**PLANNING COMMISSION
MEMORANDUM**

August 7, 2025

AGENDA ITEM: Planning File No. MAJ-24-0005: A final plan review of multi-unit residential development with 11 units and CU-24-0001, a Conditional Use application to allow for less than 20% mix of uses in the Mixed-Use District located at 200 N 7th Ave

LOCATION: 200 N 7th Ave / Lot E-2 River Pines Sub Resub Outlot E Replat A River Pines

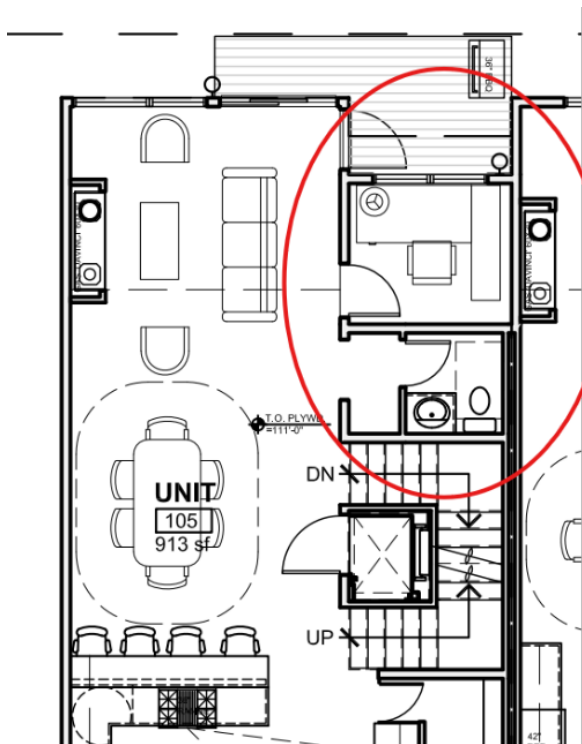
The Application now shows pedestrian access to N 7th Ave. The Applicant has also collaborated with the Town Engineer and Public Works to install a new six (6) foot sidewalk along the front property line on N 7th Ave, connecting pedestrians to the existing bike path and Summit Boulevard. The Applicant, the Town, or their assigns will be required to clear the sidewalk of snow. A maintenance agreement or Town ownership of the sidewalk will be required prior to the issuance of a building permit. With this suggested condition of approval, the Application meets this standard.

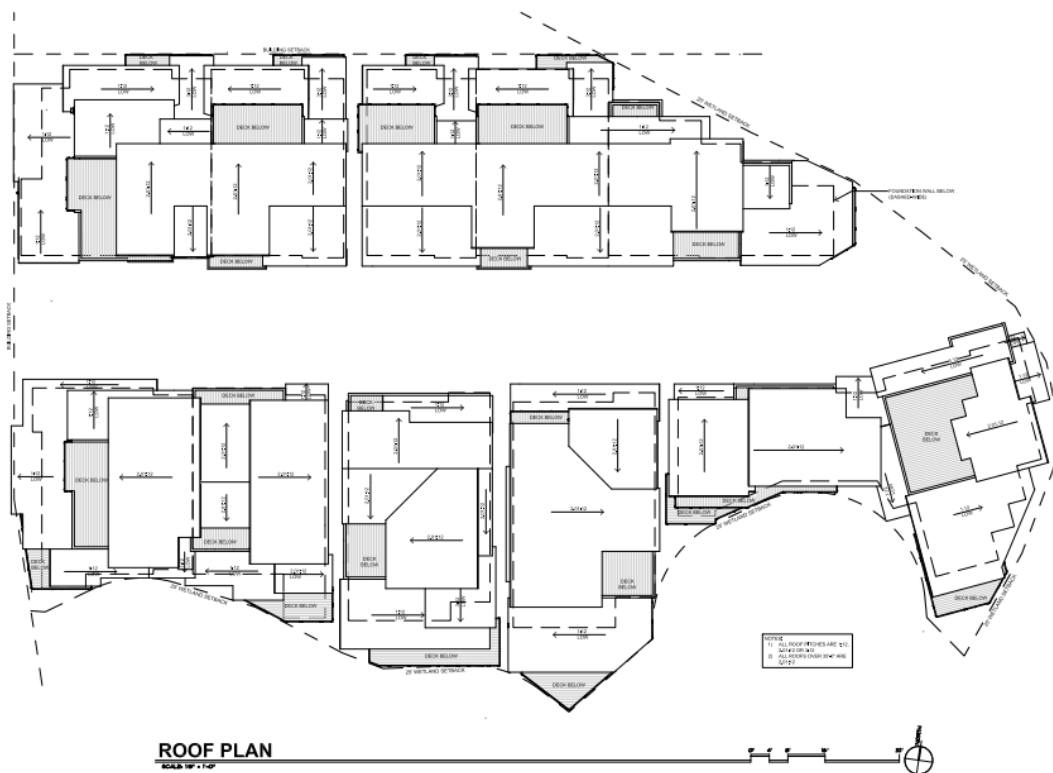
The Application shows pitched roof elements and breaks in ridgelines. No roof pitch exceeds 2.01:12, as per the roof plan.

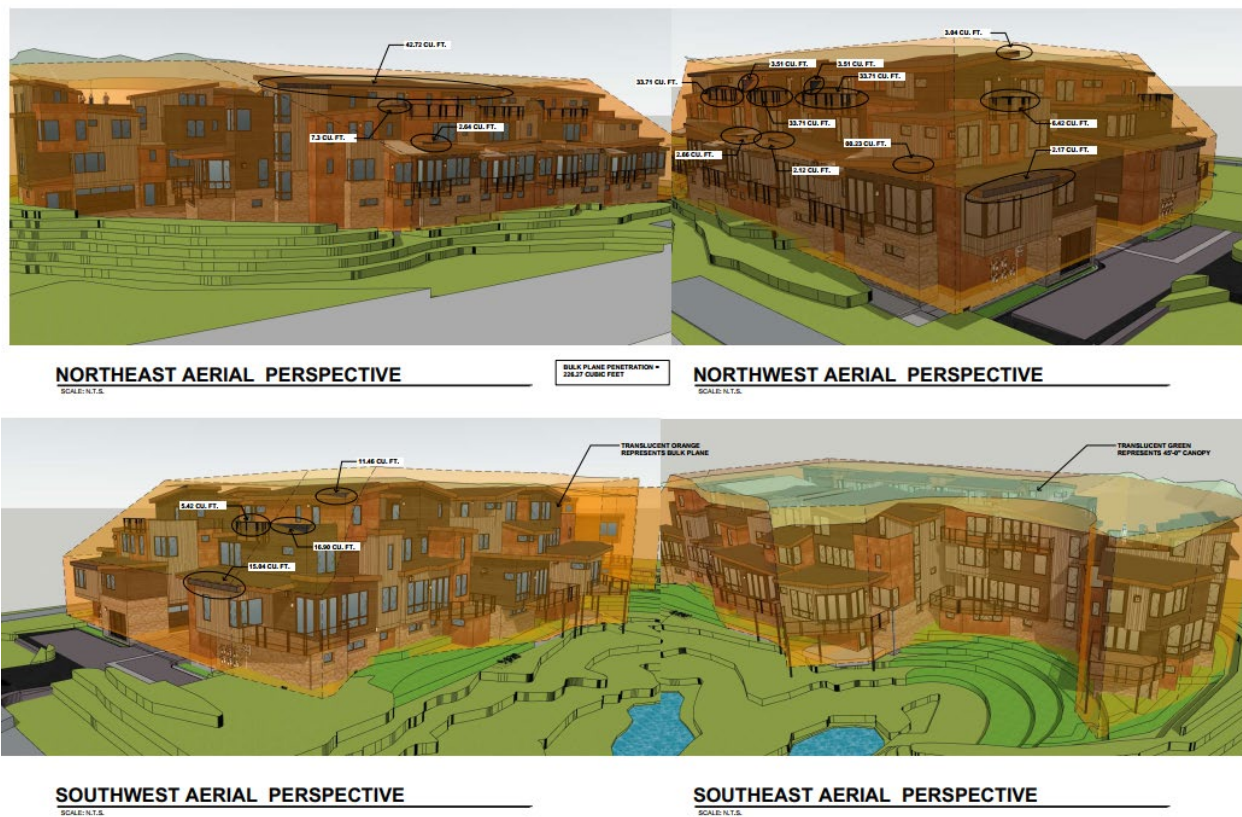
The Applicant is proposing a variety of exterior materials that appear to wrap the building corners. Therefore, this standard is met.
